Transmittal
Submittal Review Response

Re: **Project No.:** 253117-261237
Project Name: PSTA Clearwater Multimodal Transit Center
Client: Pinellas Suncoast Transit Authority

Submittal No.: **S-051200-002-F**
Title or Description: **Structural Steel Framing Canopy & Pavilion**
Type of Submittal: **Shop Drawing** **If other**
Status
Review Code: Code 4: Approved As Noted; Resubmit
Other:
Review Comments:

S-051200-002-F - Structural Steel Framing Canopy & Pavilion

LINTEL FRAMING PLAN AT WAITING PAVILION BUILDING

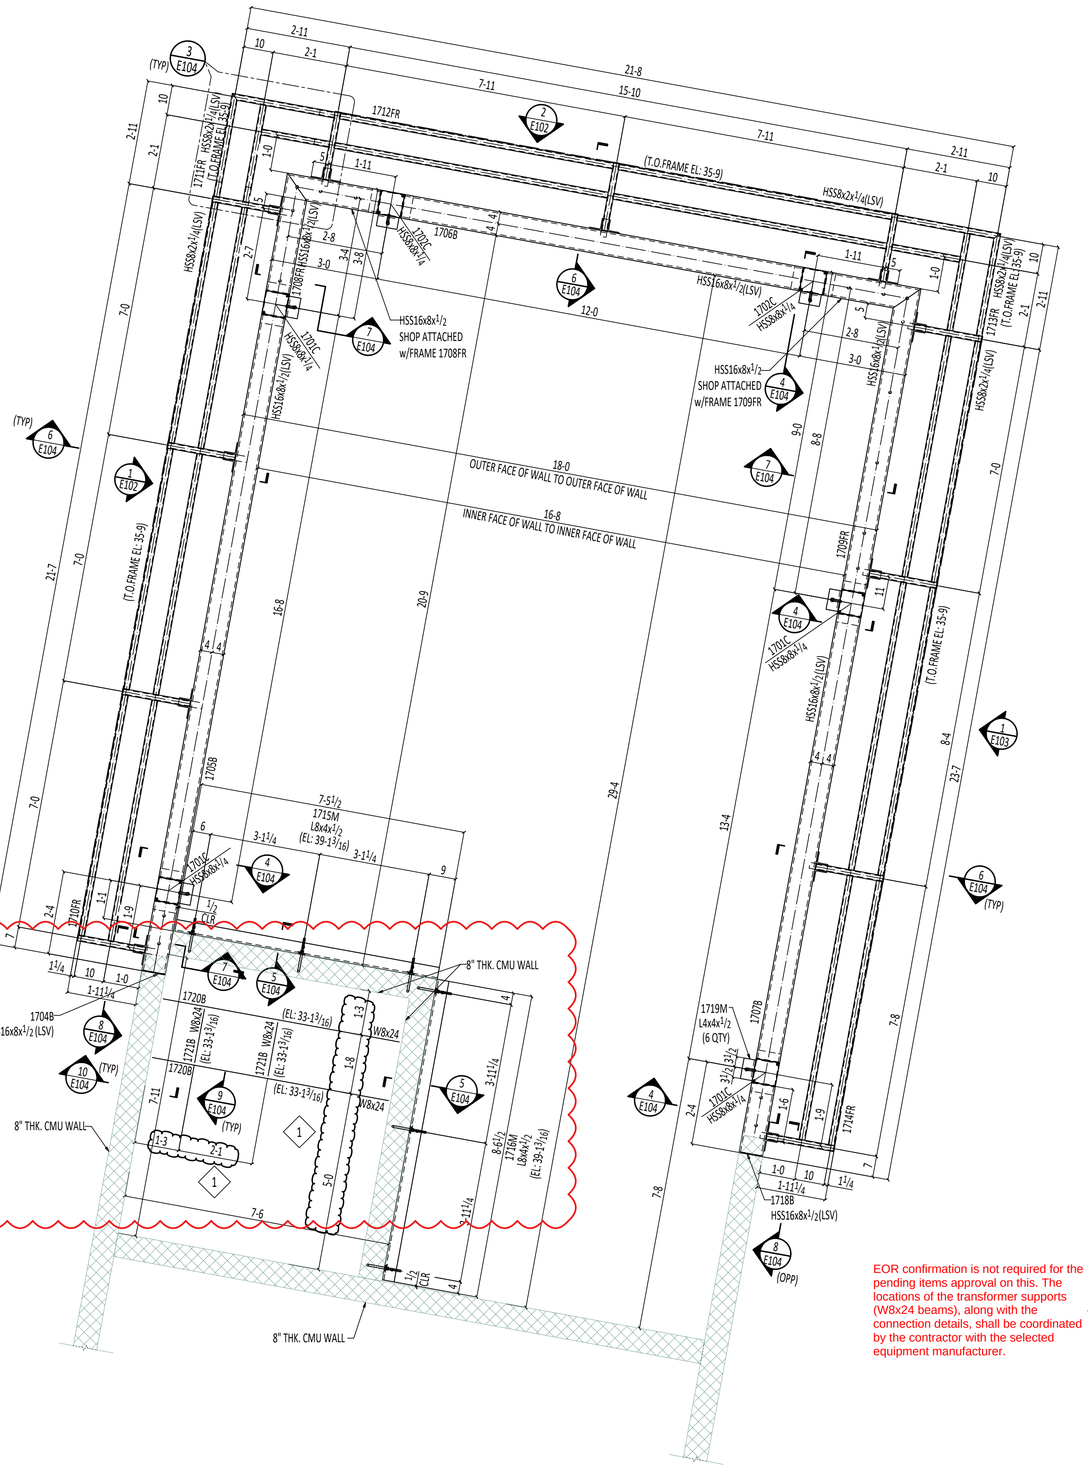
1 -GC TO CONFIRM THE CLOUDED TRANSFORMER SUPPORT BEAMS LOCATING DIMENSION WITH ELECTRICAL ENGINEERS.

EOR confirmation is not required for the pending items approval on this. The locations of the transformer supports (W8x24 beams), along with the connection details, shall be coordinated by the contractor with the selected equipment manufacturer.

1 E102 ELEVATION VIEW
(REF: 3/S-PB-3)
(OTHERS NOT SHOWN FOR CLARITY)

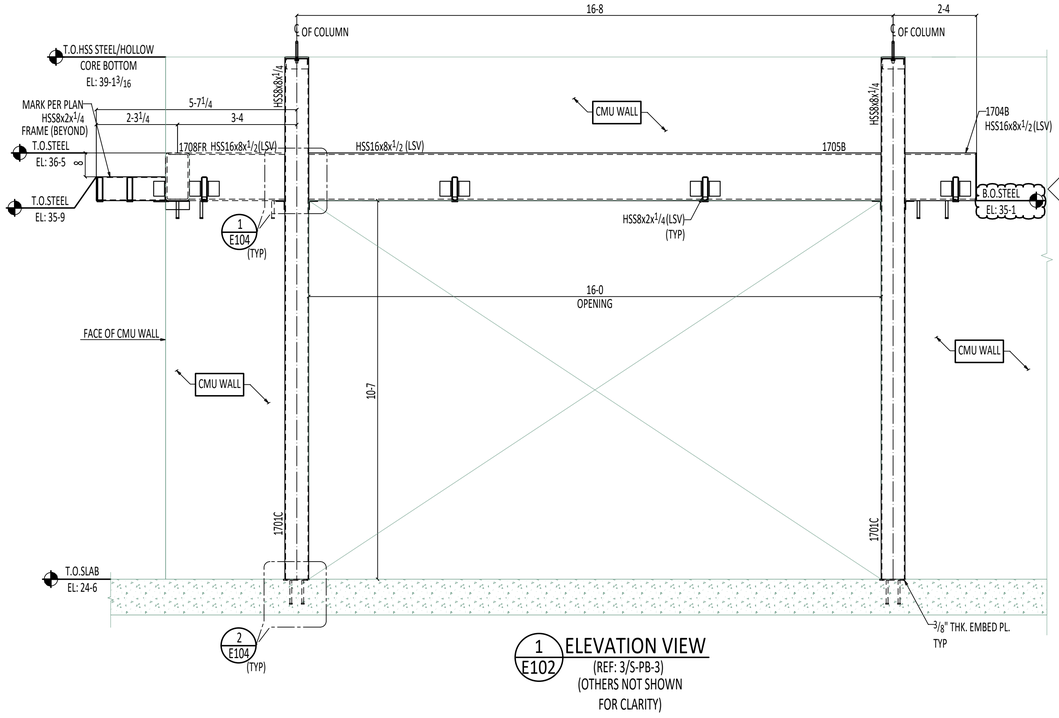
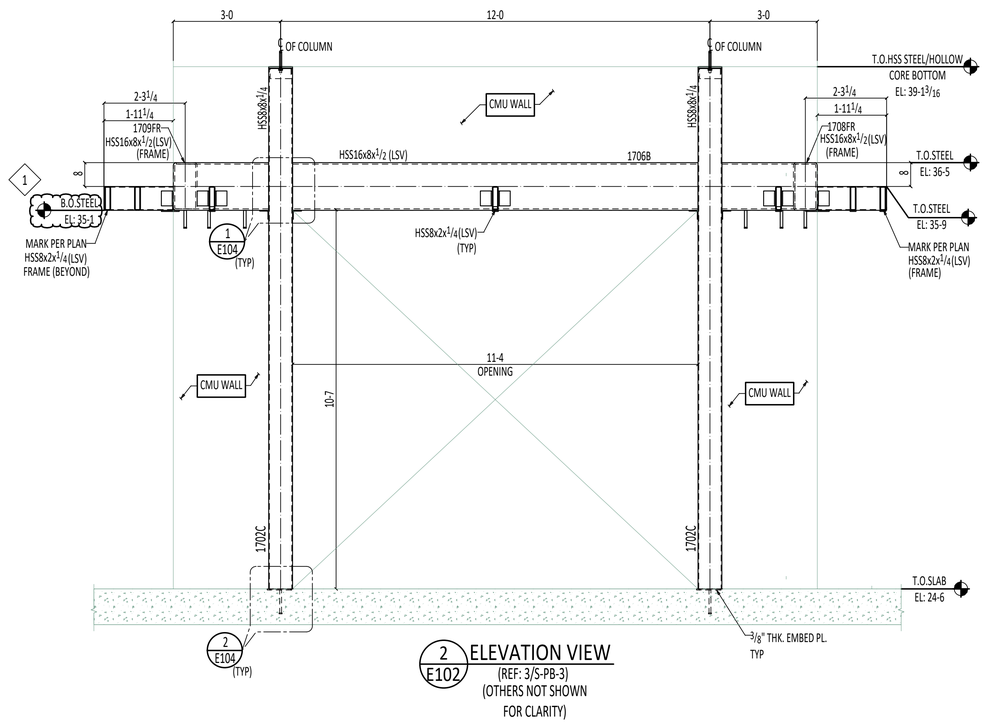
4. Contractor to confirm steel elevation on p. 6 of 231 with approved storefront (not yet submitted). Engineer confirms intent is met. This is a repeat comment and Contractor has indicated coordination to still be completed.

1 -GC TO CONFIRM THE BOTTOM OF STEEL ELEVATION WITH STOREFRONT & CONCRETE CURB MANUFACTURER.

24. Storefront steel elevation
EOR previously confirmed design intent. Final bottom-of-steel elevation will be coordinated with storefront and curb manufacturer information before affected fabrication.

1 E103 ELEVATION VIEW
(REF: 3/S-PB-3)
(OTHERS NOT SHOWN FOR CLARITY)

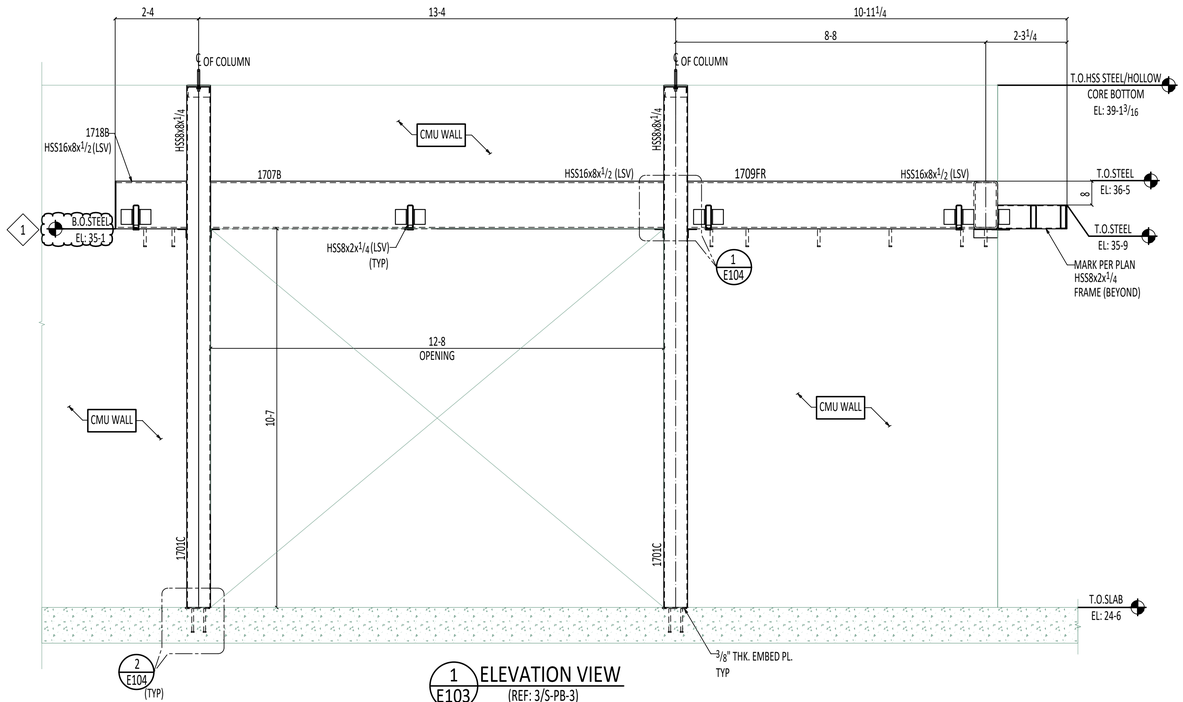
1 -GC TO CONFIRM THE BOTTOM OF STEEL ELEVATION WITH STOREFRONT & CONCRETE CURB MANUFACTURER.

10 E104 SECTION VIEW
(REF: 6/S-PB-1)
(OTHERS NOT SHOWN FOR CLARITY)

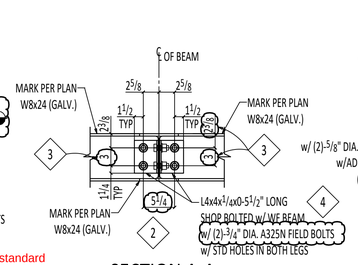
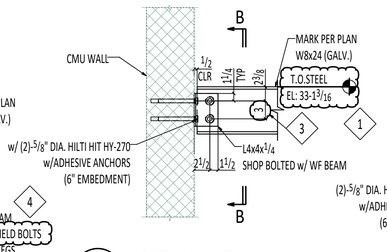
1. - PLEASE VERIFY AND CONFIRM THE TOP OF BEAM ELEVATION WITH FINAL APPROVED TRANSFORMER COORDINATION DRAWINGS.
   Contractor to coordinate with the selected transformer manufacturer
2. IF WE MAINTAIN A 1 1/2" EDGE DISTANCE, THE RESULTING HOLE C/C DIMENSION WILL BE 5 1/4", AS SHOWN. PLEASE CONFIRM WHETHER THIS IS ACCEPTABLE.
   It is acceptable
3. IF WE FOLLOW 4" BOLT SPACING PER CD, THNE THE ANGLE WILL CLASH WITH BEAM K VALUE. HENCE WE FOLLOWED 3" SPACING. PLEASE CONFIRM WHETHER THIS IS ACCEPTABLE.
   If 4" spacing is maintained, there will be a slight clash with the beam root radius which should be fine. But the bolt spacing can be reduced to 3 1/2" to avoid the conflict with the root radius.
4. AS PER STANDARD PRACTICE, WE HAVE USED 3/4" DIA. BOLTS INSTEAD OF THE 5/8" DIA. BOLTS SHOWN IN THE CD. PLEASE CONFIRM WHETHER THIS IS ACCEPTABLE.
   It is acceptable

Use the standard hole 13/16" diameter per Table J3.3 of AISC 360

PARTIAL ROOF FRAMING PLAN

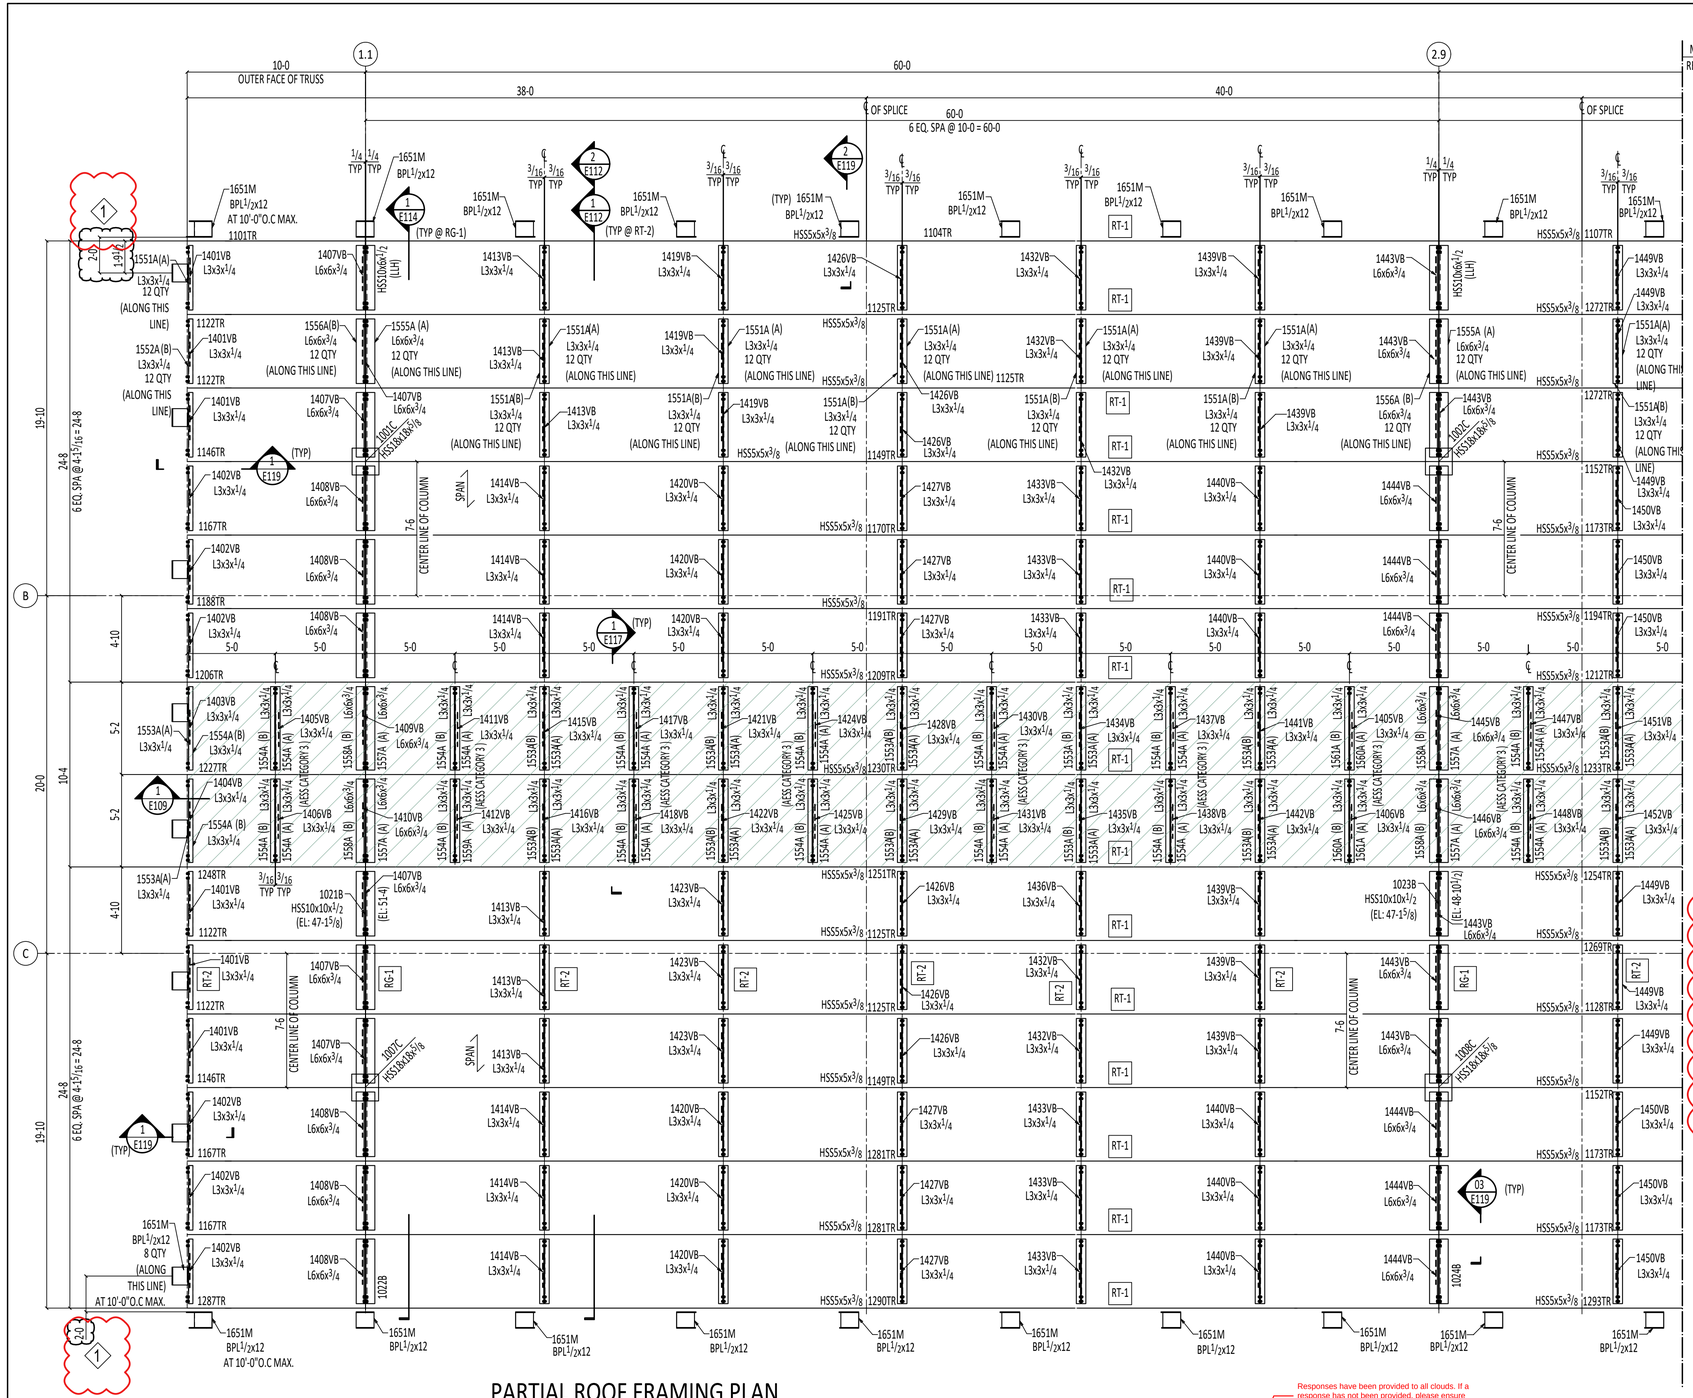
28. Receipt acknowledge od drawing E121 Wave Canopy roof hatch. However, hatch location is not shown on E106 partial roof framing of wave canopy. Contractor to locate and properly adjust roof hatch on E106.

Responses have been provided to all clouds. If a response has not been provided, please ensure Engineer is aware to respond to.

1 E110 ROOF TRUSS ELEVATION VIEW-1 (RT-1)

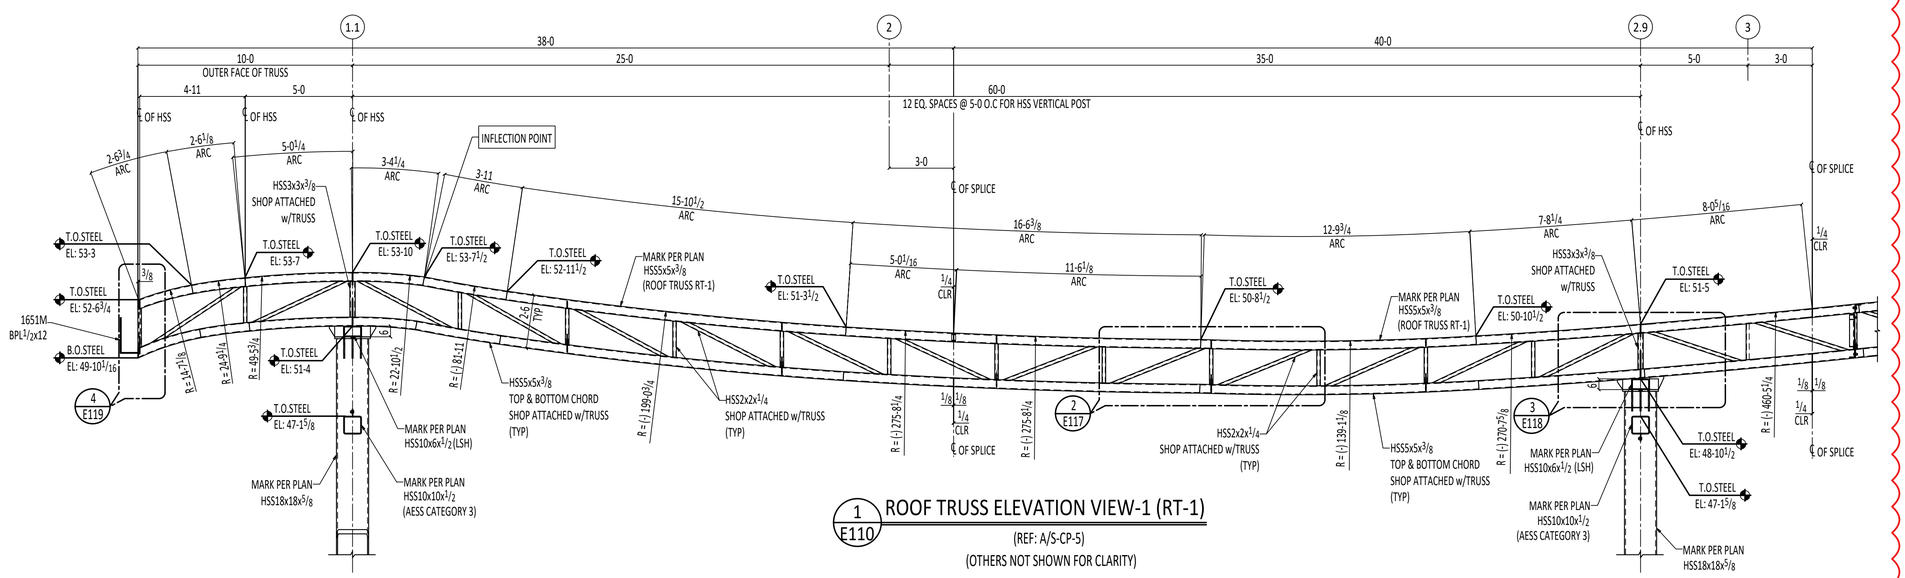
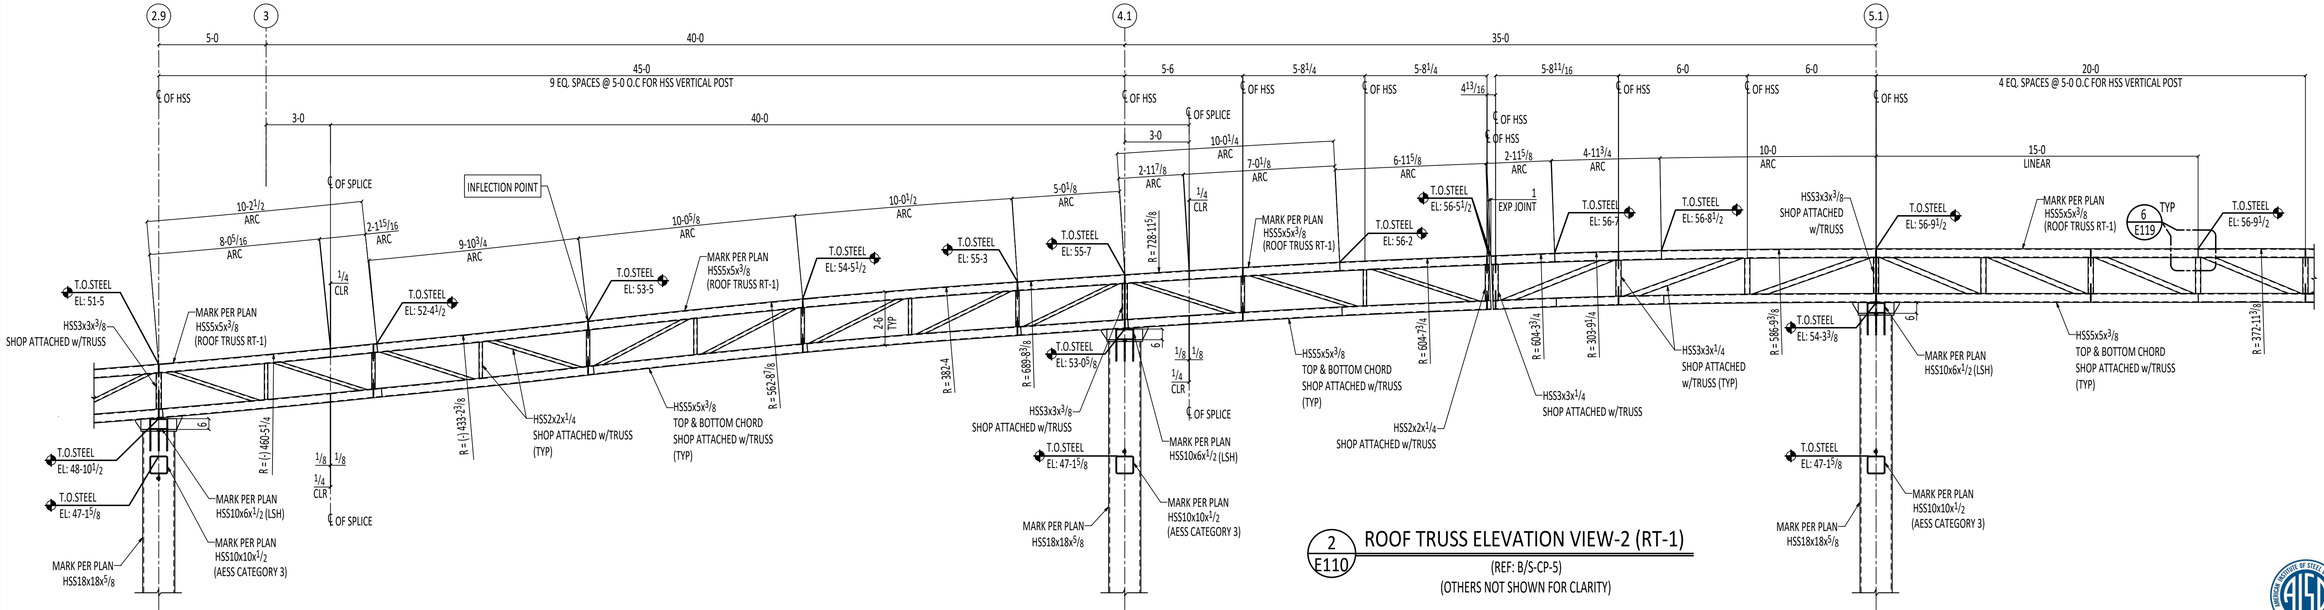
5. There is a mismatch between the dimensions and wave truss bend radii shown on the overall truss longitudinal drawings, E110 and E111, and those shown on the contract drawings and typical truss shop drawings, Drawing Nos. 1176 through 1200. Coordinate between the drawings and ensure that

all dimensions and bend radii are consistent with and accurately reflect the requirements shown on the contract drawings.
